Certification of Noise Wall Design: Resource Recovery Facility at 23-43 and 45 Tattersall Road, Kings Park NSW

Preliminary Engineering Advice for Proposed Noise Wall Flood Management Requirements, Resource Recovery Facility at 23-43 and 45 Tattersall Road, Kings Park NSW

Attachment 3: Structural Drawings (Northrop, 2024)

Figure 1: Recommended culvert locations.

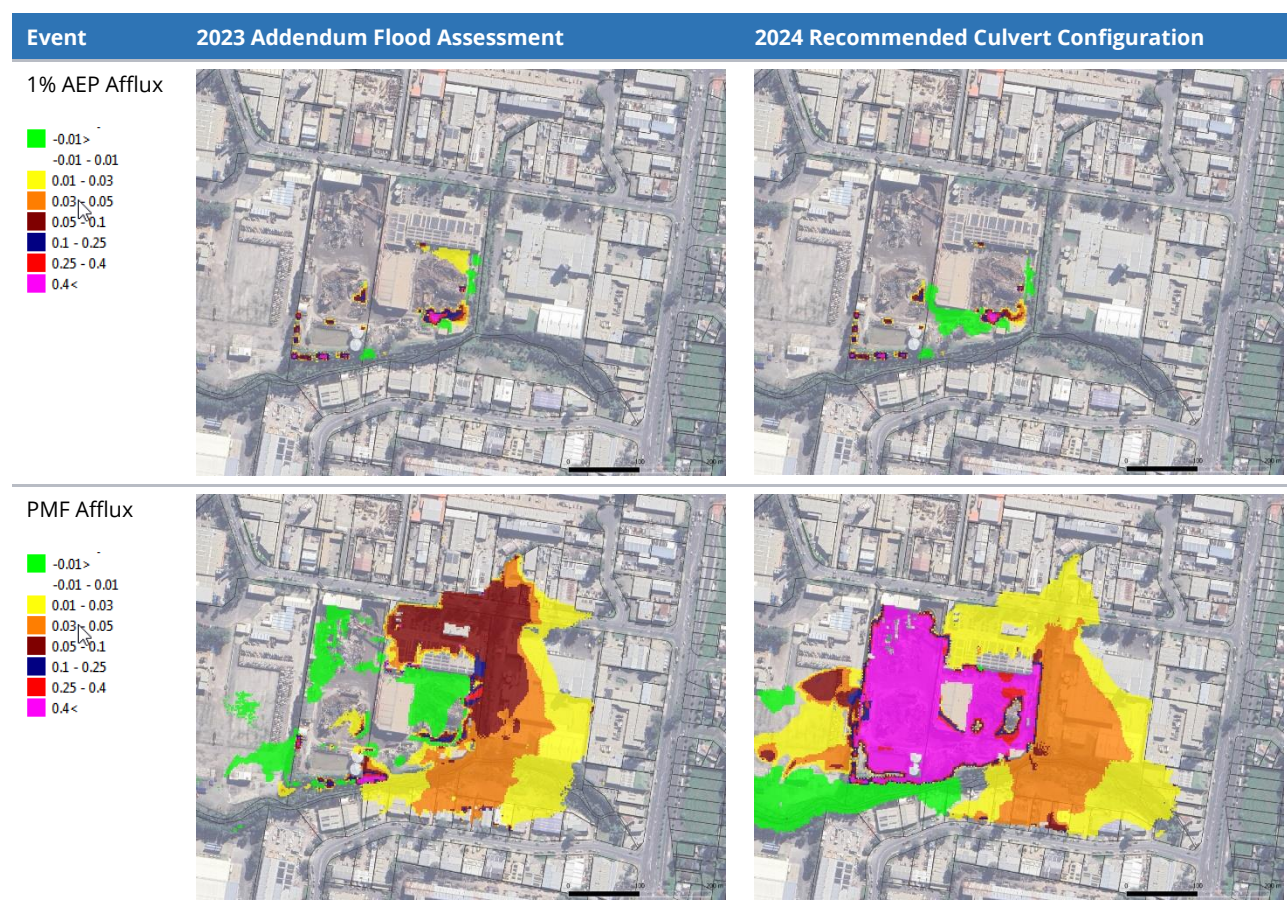
Based on the above methodology, we recommend that four culverts, each with 2 m wide x 1 m high openings, are required. Recommended locations are provided in Figure 1.

At Table 1 we have plotted 1% AEP and PMF flood level afflux resulting from the Noise Walls, comparing the 2023 Arcadis Addendum Flood Assessment outcomes with those contained in this advice. We observe that the recommended culverts, consistent with the Addendum Flood Assessment, do not impact off-site 1% AEP flood levels. Off-site PMF impacts are reduced to the east and north due to the minor model correction (noted at Section 4) and correspondingly marginally increased to the west. In general, PMF afflux is consistent with the Addendum Flood Assessment and considered acceptable. The recommended culvert arrangement therefore satisfies condition C1(a)(ii).
